Technical Service Bulletin

Subject: TSB - New CP100/CP200 Main PCBA and Wire Harness with ESD shield.

Product(s) Referenced: CP100 and CP200 Electrocardiographs

Summary: New PCBA 405472 (ASSY, MAIN PCA, CP100/200 PATTERN 8) replaces old 404800 (ASSY, MAIN PCA, NORMANDY PATTERN 7, PLUS).
New harness 714834 (HARNESS W/ ESD SHIELD) replaces 700157 (HARNESS, PWR SUPPLY TO MAIN PCB (W002)).
Add cable tie mount 113P463 (CABLE TIE MOUNT).
Add foam strip 78P567 (FOAM STRIP, .75 SQUARE).
Add foam strip 703772 (DBL COATED FOAM TAPE, .062 THK. 1" W).
Add Nomex ESD shield 714833 (ESD SHIELD, NOMEX).
Remove label 704167 LABEL, STATIC COVER.

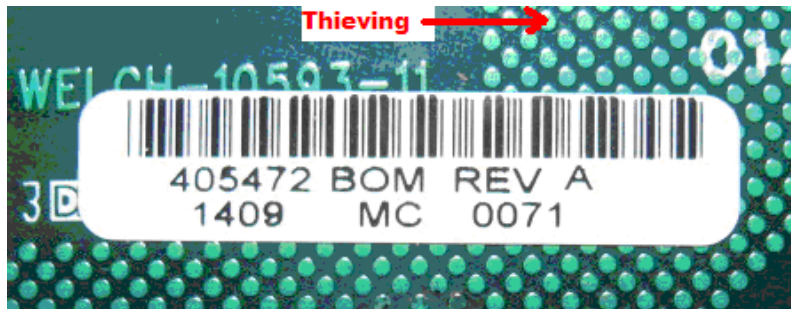
Note: The new main PCBA 405472 is distinctly recognizable by the **thieving** used in the PCB manufacturing process. See the example below.

Figure 1

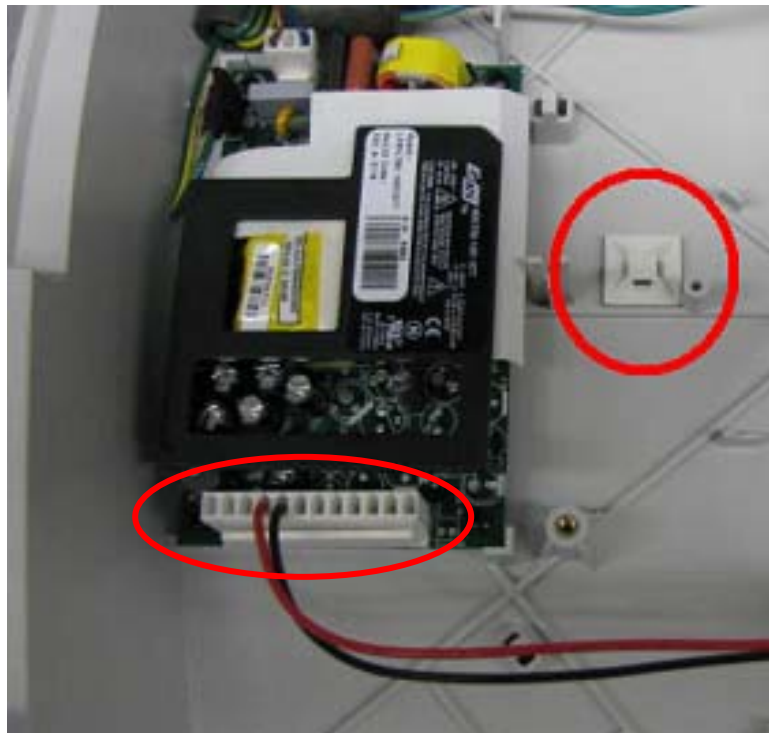
1. Replace the old harness with the new 714834 (HARNESS W/ ESD SHIELD) and connect the harness to the Power Supply (703611). Install Foam Strip (78P567) onto the Cable Tie Mount (113P463). Install the cable tie mount into housing 400042 located as shown. Justify the cable tie mount to the rib and boss as pictured (Figure 1).

Figure 2

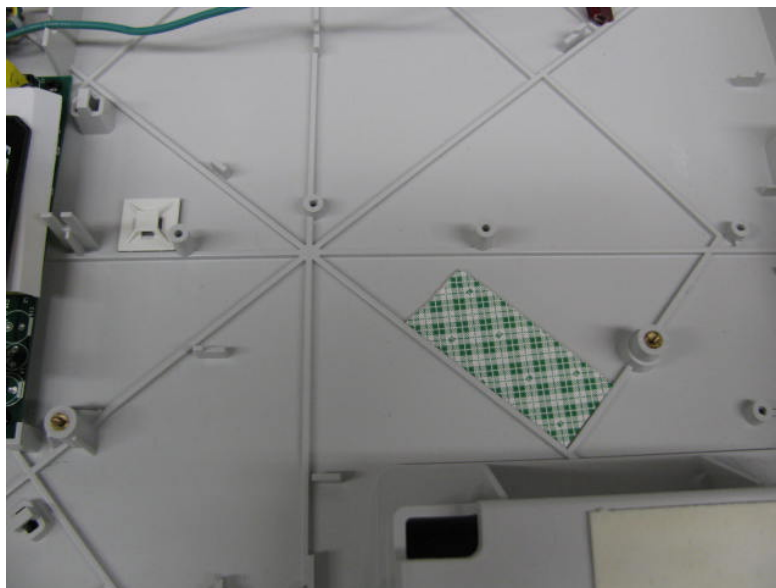
2. Install approximately 2" of foam tape (703772) into housing located as shown. Justify the tape to the ribs as pictured (Figure 2).

Figure 3

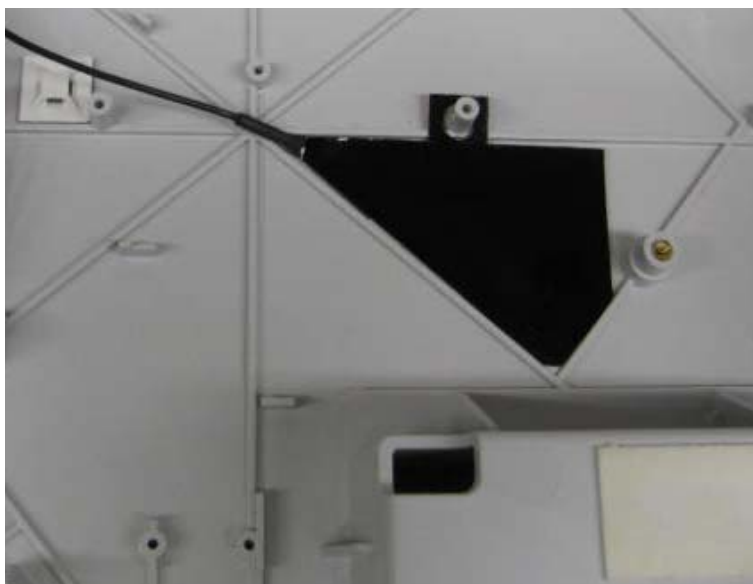
3. Remove backing from foam tape. Install the copper shield 714834 into the base housing copper side down making sure that the copper is aligned correctly and the hole is oriented over the mounting standoff as shown (Figure 3).

Figure 5

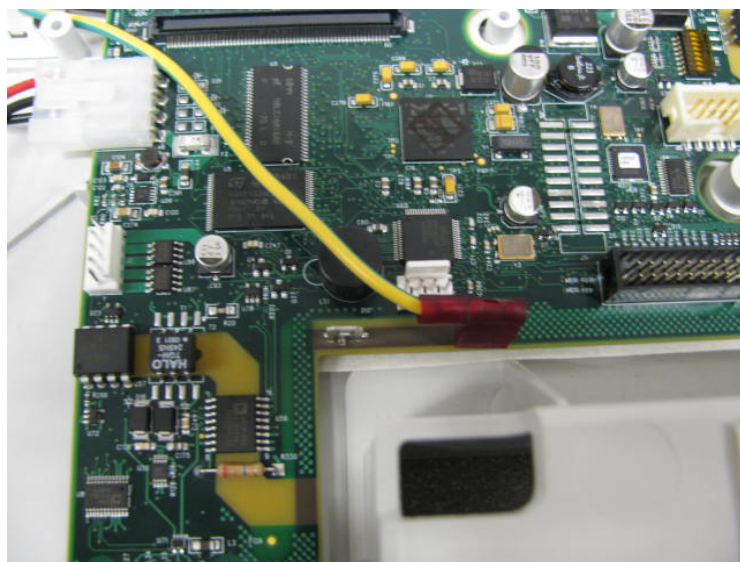
5. Install main board (405472) into housing using 5 Screws (106124-4). Connect (740068 long green/yellow wire) to the main board terminal J5 as shown (Figure 5).

Figure 6

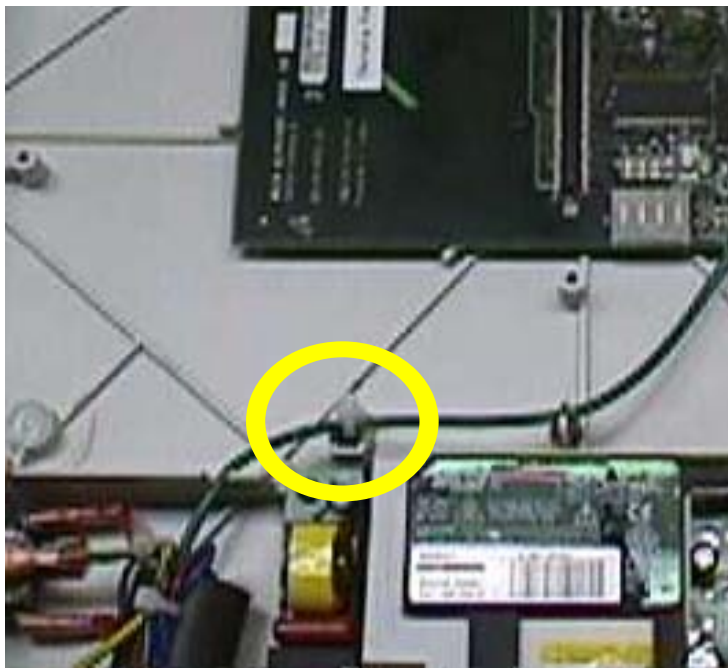
6. Fasten 740068 (long green/yellow wire) with a wire tie (761077-1). Circled area in picture below indicates wire tie location (Figure 6).

Figure 8

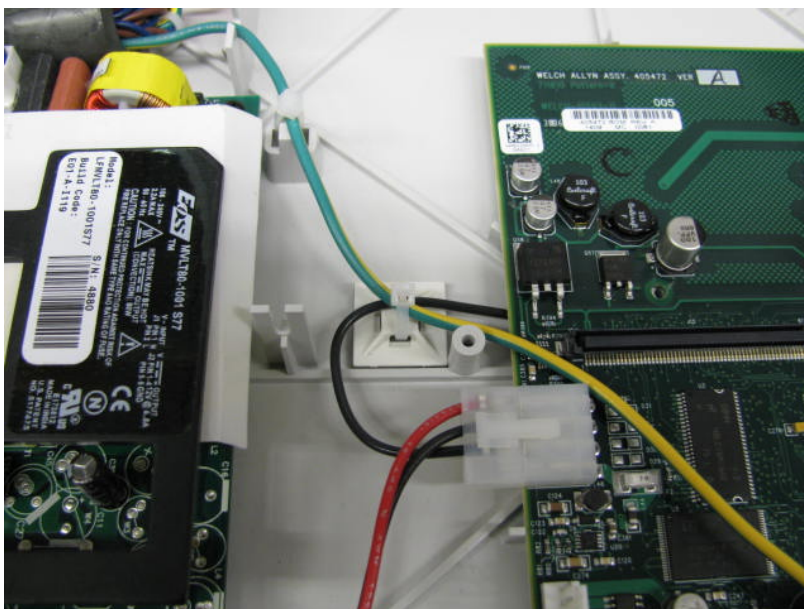
8. Connect wire harness 714834 to the main PCBA 405472 at J20. Secure both 704068 (green/yellow wire) and the ESD shield wire (black) to the Cable Tie Mount (113P463) as shown (Figure 8).

Figure 9

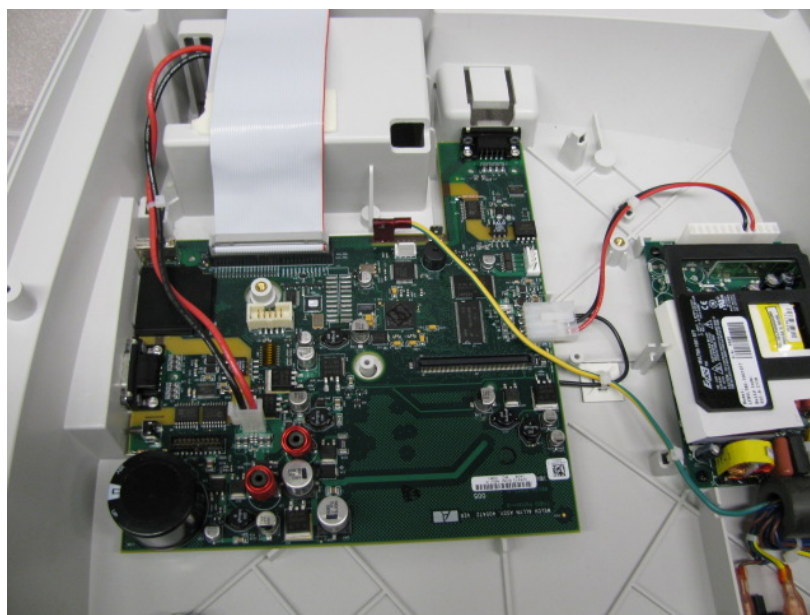
9. The completed base assembly should resemble the picture below (Figure 9).

Figure 10

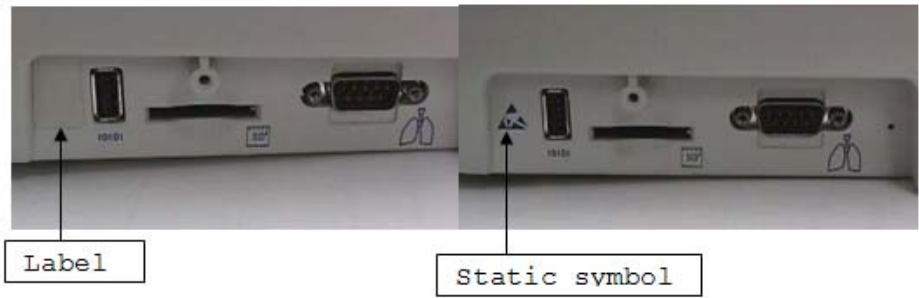
10. Remove the label 704167 to expose the static symbol as shown
